Leadframe Rework on ACTEL CQFP Packages

The following describes a notch that is put at the end of leads, near the ceramic leadframe during rework. The standard leadframe rework is frequently mistaken as visual rejects like bent leads and scratches.

**Form Factor for Notched Rework
per MIL-STD-1835B**

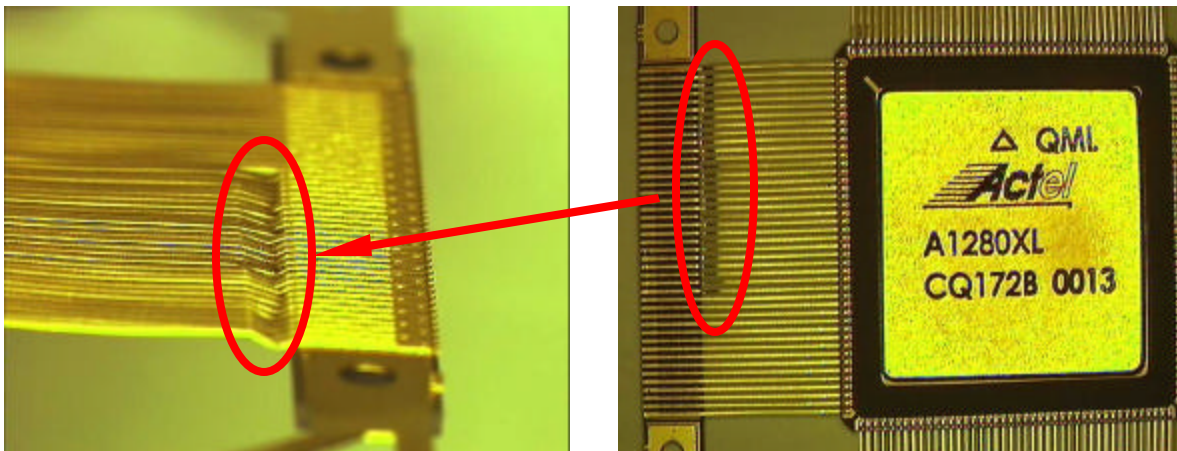
CQFP packages have straight leads that are very thin and narrow in width, therefore, the leads are easy to bend during the manufacturing process. To effectively straighten the bent leads at final visual inspection, Actel implemented a procedure to mechanically put a notch at the end, near the ceramic leadframe (see picture). The form factor of this rework is clearly defined on MIL-STD-1835B, Notice 2, detail G on page 136 (see sketch), and note 11 on page 141.

The reworked leadframe will not affect the device programming and testing performed at customer site, and the reworked area must be removed prior to lead forming process. Therefore, there shall be no concern on device form-fit factor, functionality, and reliability as the result of this rework.
